**DOS RIOS WRC CHLORINE SYSTEM IMPROVEMENTS**  
**Solicitation Number: CO-00197**  
**Job No.: 17-6508**

**ADDENDUM 3**  
**September 19, 2018**

DRAWING NUMBER **20-M132**

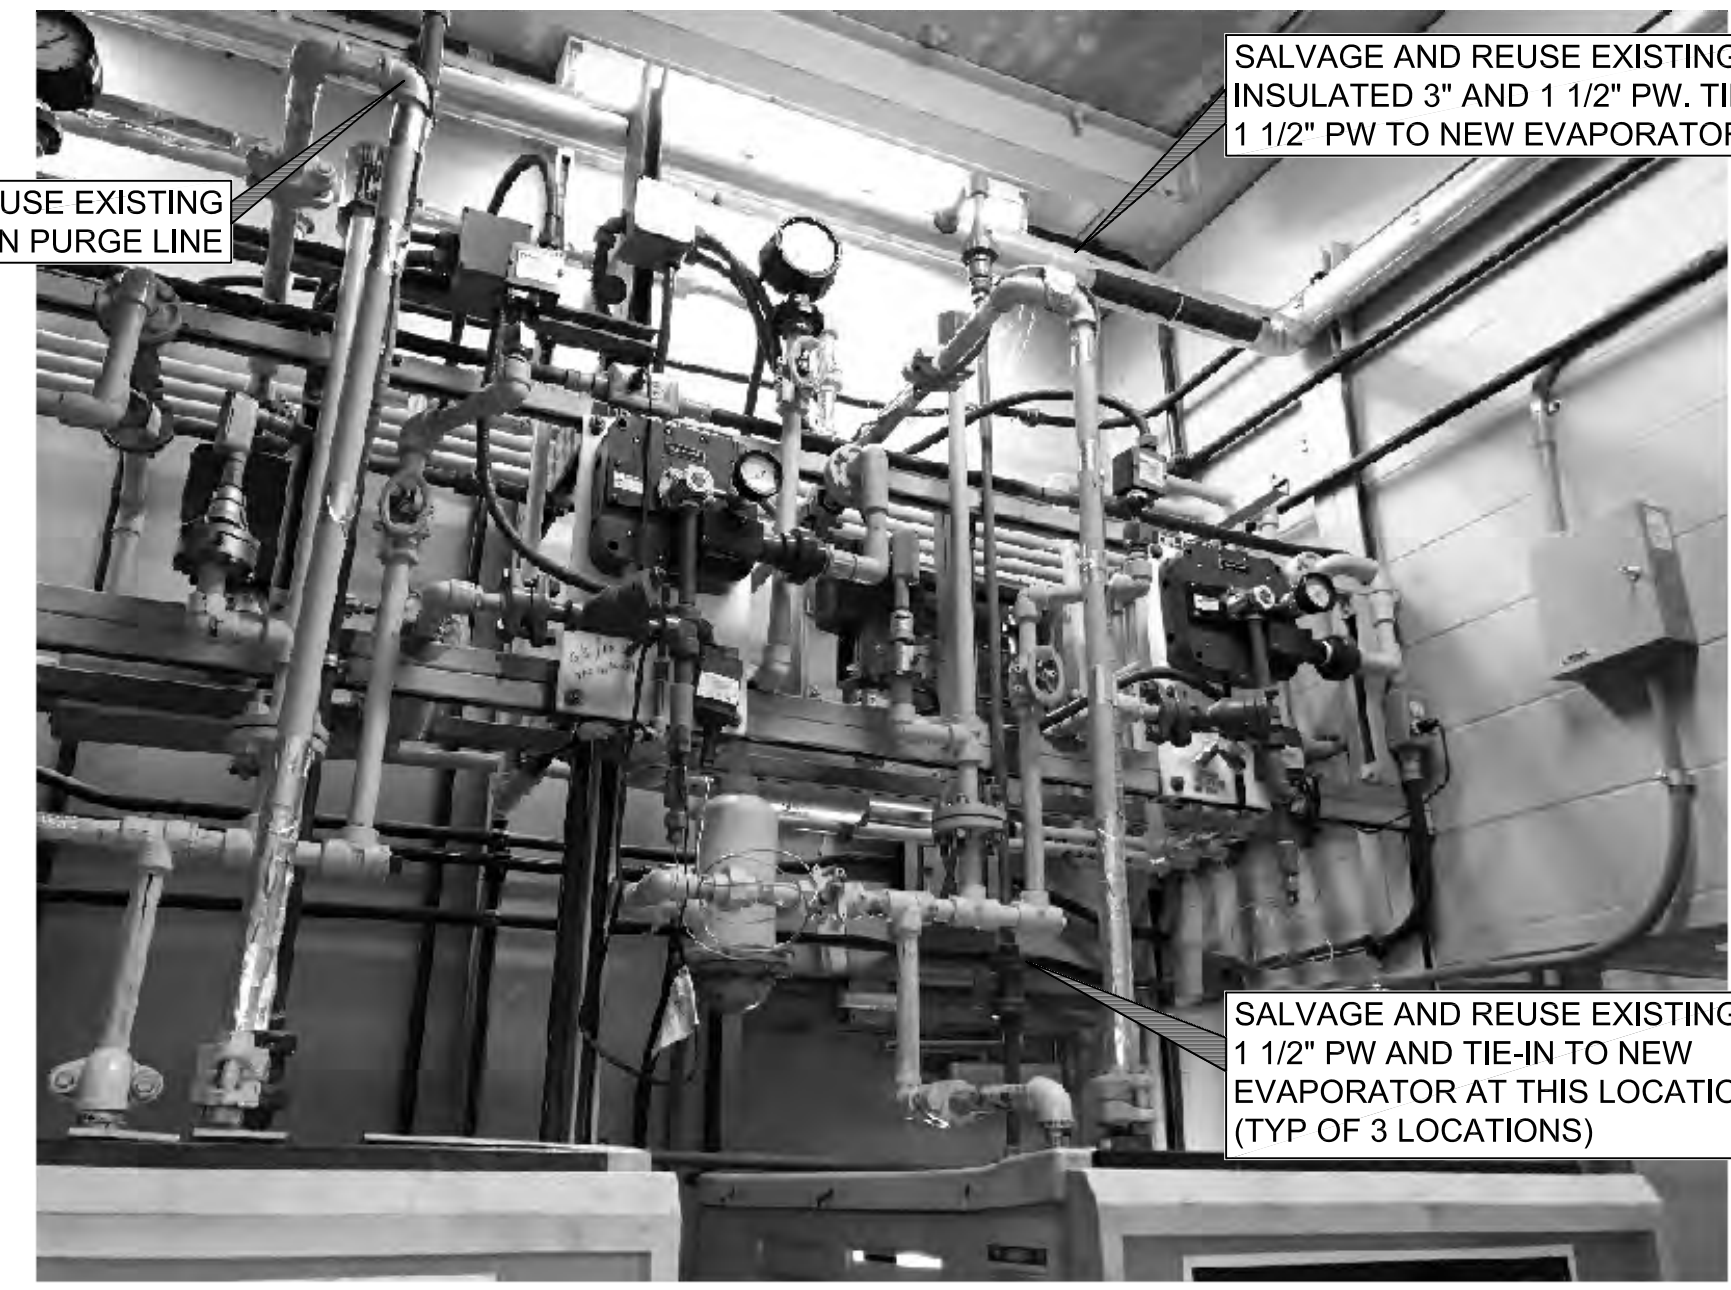
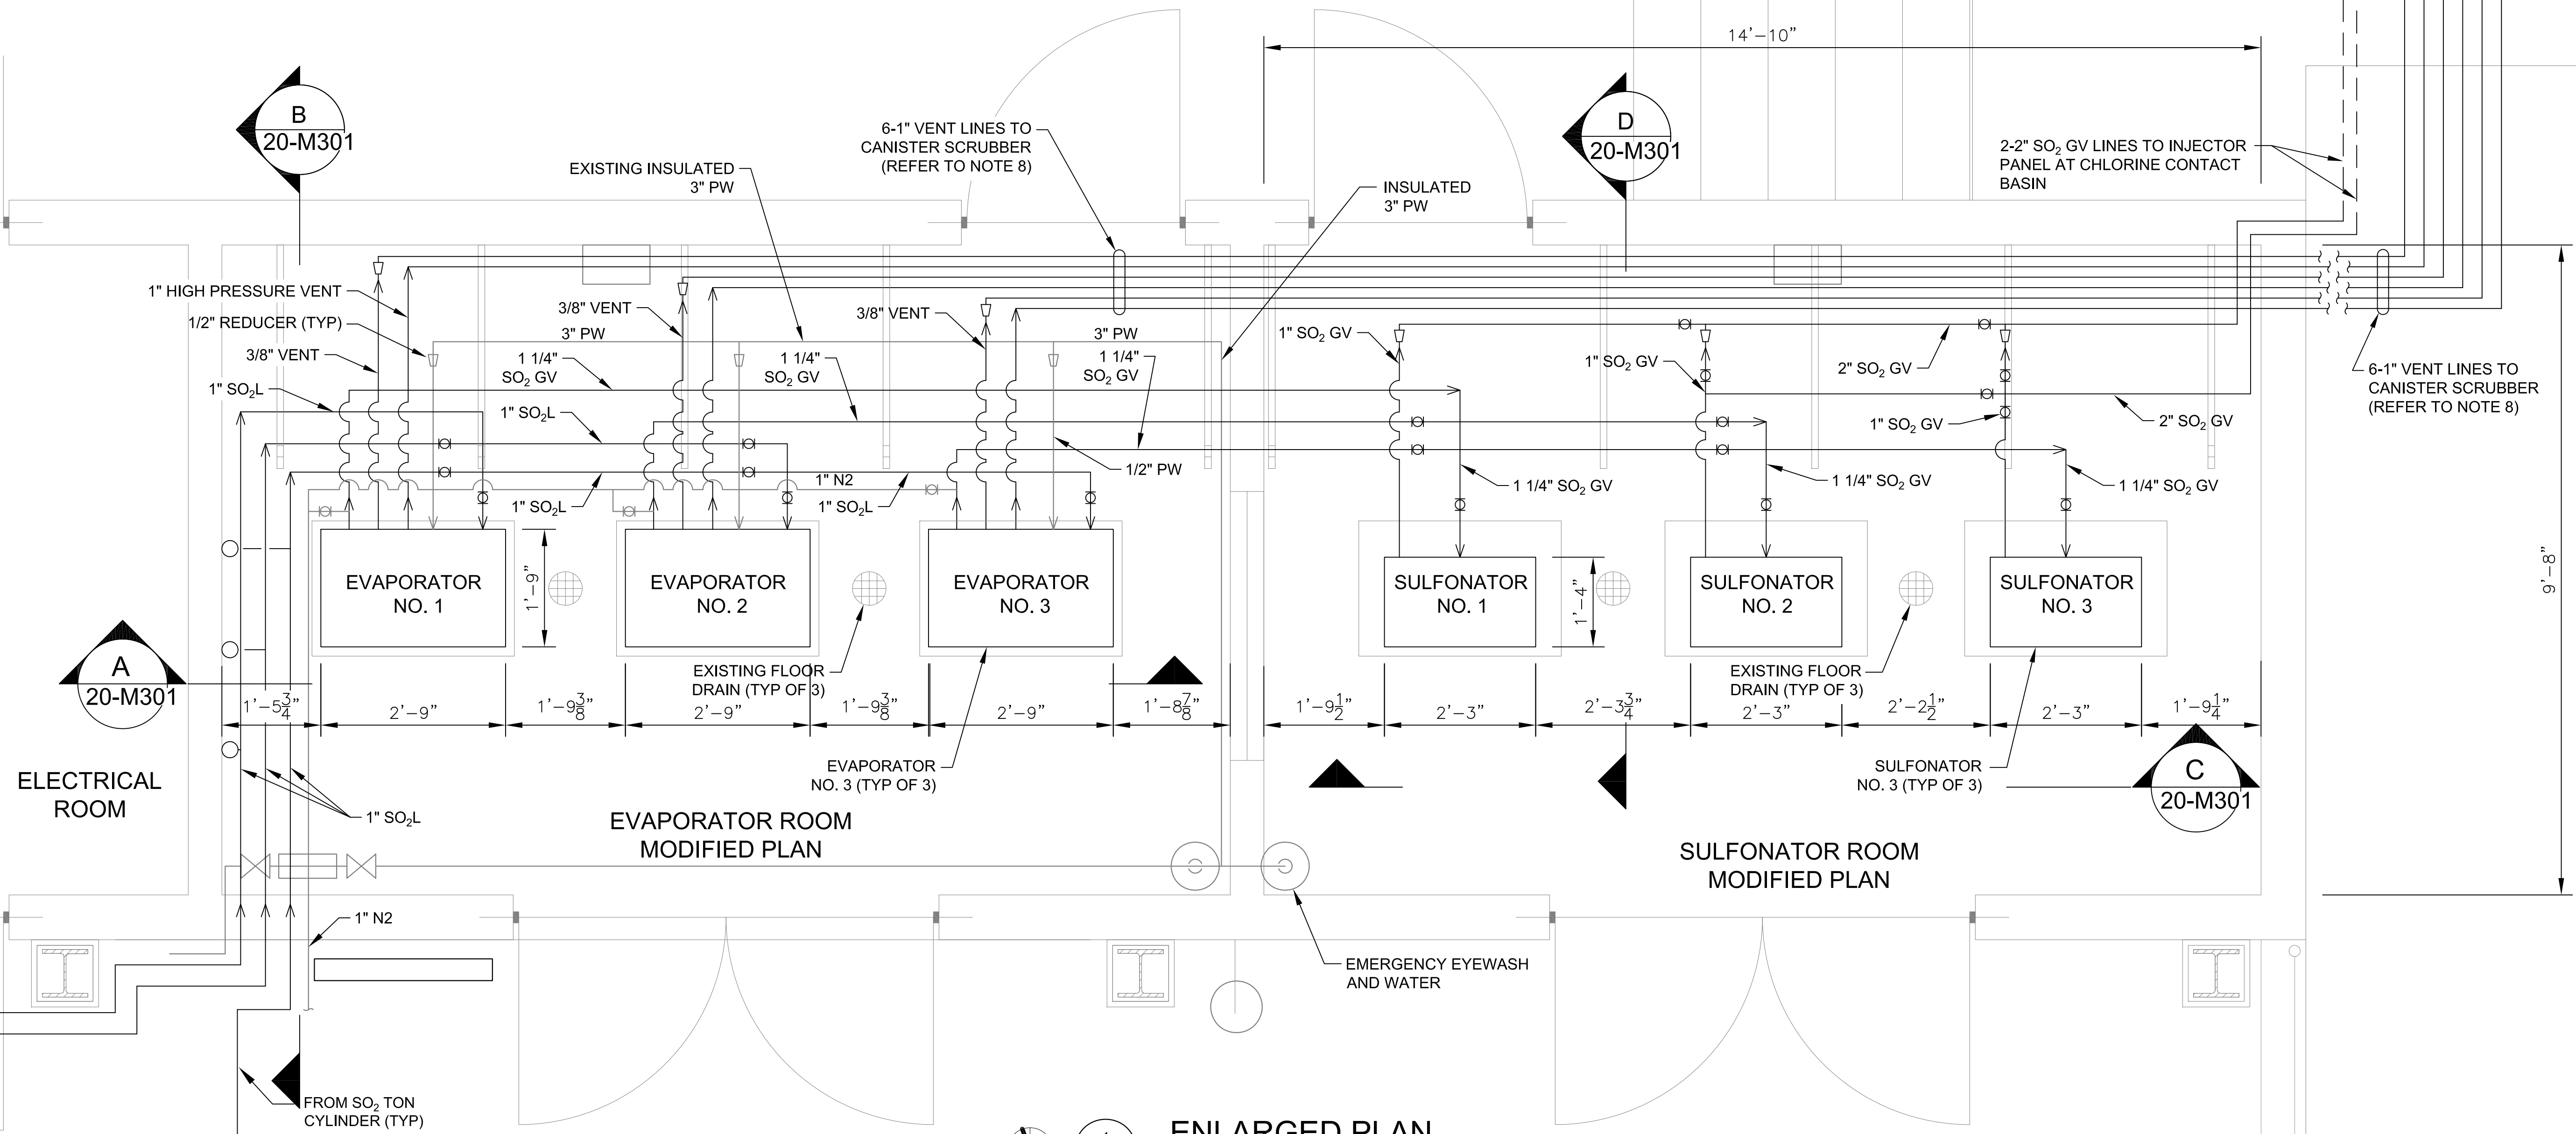
21. DWG 20-M301, Section A: Where does the nitrogen purge line come from? What size? Not shown on 20-M132

42. Sheet 20-M132
  - a. Replace the sheet with the attached. Modifications are summarized as follows:
    - Added individual vent lines from each of the evaporator vacuum regulators to the scrubber canister.

- Clarified location of existing 3-inch and 1/2-inch Potable Water (PW). PW line will be connected to the evaporator. Existing PW in the Evaporator and Sulfonator Room shall be reused and not demolished.

Response: Refer to revised DWGs 20-M132 and 20-M301. Information pertaining to the purge line was added.
